# UNITED STATES PATENT AND TRADEMARK OFFICE

APPLICATION NO.	FILING DATE	FIRST NAMED INVENTOR	ATTORNEY DOCKET NO.	CONFIRMATION NO.
10/702,294	11/06/2003	Gerd Ulbers	KEL 008 P2	8082
34232	7590	06/02/2006	EXAMINER	
MATTHEW R. JENKINS, ESQ. 2310 FAR HILLS BUILDING DAYTON, OH 45419			LARYEA, LAWRENCE N	
			ART UNIT	PAPER NUMBER
			3735	
DATE MAILED: 06/02/2006

## Office Action Summary

## **DETAILED ACTION**

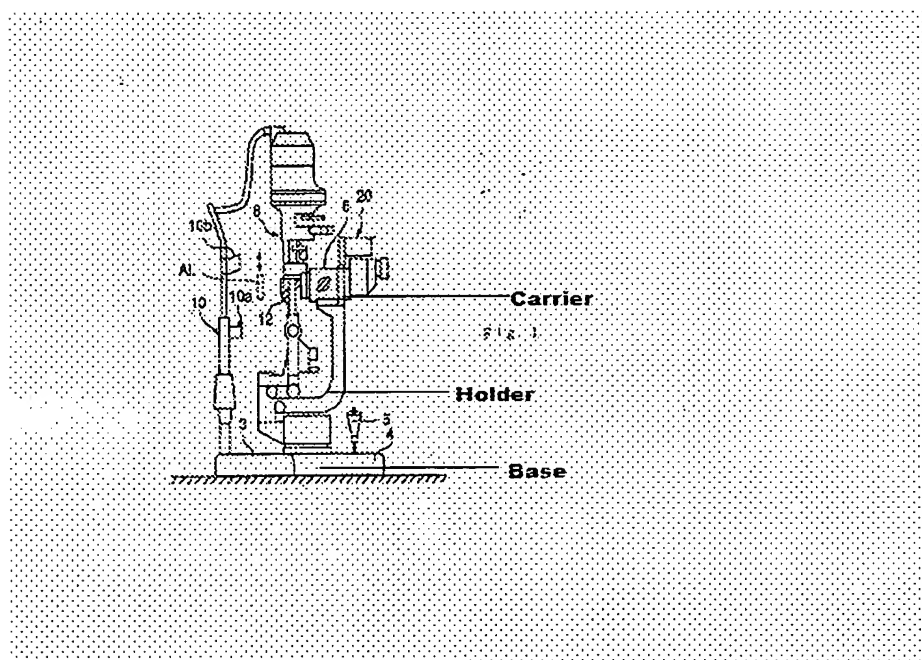
**12. Claims 1-4,7,11-15,17-19,22-25,28,32 are rejected under 35 U.S.C. 102(b) as being anticipated by Okamoto et al (US 2001/0028441). Okamoto et al teach an ophthalmologic apparatus which comprises of the following:**

**13. Re Claims 1 and 22:** Okamoto et al teach a device for viewing an eye of a patient, in particular a slit-lamp unit **See paragraph [0015,line 1-2]**, comprising viewing means **See paragraph [0014, line 7-8]** for viewing a front section of the eye and illuminating means **See paragraph [0016,line 1-9]** for illuminating the front section of the eye, characterized in that the illuminating means **See paragraph [0016,line 1-9]** are designed in such a way that it is also possible to illuminate a rear section of the eye **See paragraph [0016,line 1-9]**, and that the device comprises optical imaging means(**See Fig.2, AL**) for imaging the rear eye section, and an image acquisition device(**See Fig.2 unit 20**) for acquiring images of the eye with the aid of an image recording device(**See Fig 1, unit 43**), the image recording device being designed and capable of being positioned such that it is possible thereby to image the rear eye section without reflections ophthalmoscopically.

**14. Re Claims 2 and 23:** Okamoto et al teach that the illuminating means comprise a light source **See paragraph [0016,line 1-9]** for generating an illuminating beam **See paragraph [0016,line 1-9]**, and can be switched over from background illumination to foreground illumination. **See paragraph [0022].**

15. Re Claims 3,13 and 24: Okamoto et al teach that the image acquisition device comprises a deflecting device (**See Fig.2 unit 34**), it being possible to position the deflecting device in front of the eye such that a viewing beam emerging from the eye can be deflected through the image recording device. (**See Fig 1, unit 43**).

16. Re Claims 4, 14,15 and 25: Okamoto et al teach that the illuminating means comprise a light source and form a unit with the image acquisition device, it being possible to deflect a viewing beam generated by the light source onto the eye by the deflecting device (**See Fig 1,12**).

17. Re Claims 7,17,18,19, and 28 : Okamoto et al teach that the image acquisition device comprises a holder with a base and a carrier, the image recording device being fastened on the carrier, the base being connected moveably to the device, and the holder having guide means for displacing the carrier relative to the base. (**See Fig.1**)

18. Re Claims 11 and 32: Okamoto et al teach that the device according to one of claims 1, characterized in that the optical imaging means for imaging the rear eye section are positioned near the eye. **See paragraph [0052] (See Fig.2). The optical imaging means for imaging the fundus are position near the eye.**

19. Re Claims 12 and 33: Okamoto et al teach that the image acquisition device is designed in such a way that it can be switched over between at least two magnifications. **See paragraph [0068]. In the case where the switch is provided, if the front eye portion observation is performed in the switch-off and the eye fundus portion observation is performed in the switch-on, an advantage that the optical parts are necessarily inserted onto the optical axes in the eye fundus portion observation is obtained. See paragraph [0064,line6-7].**
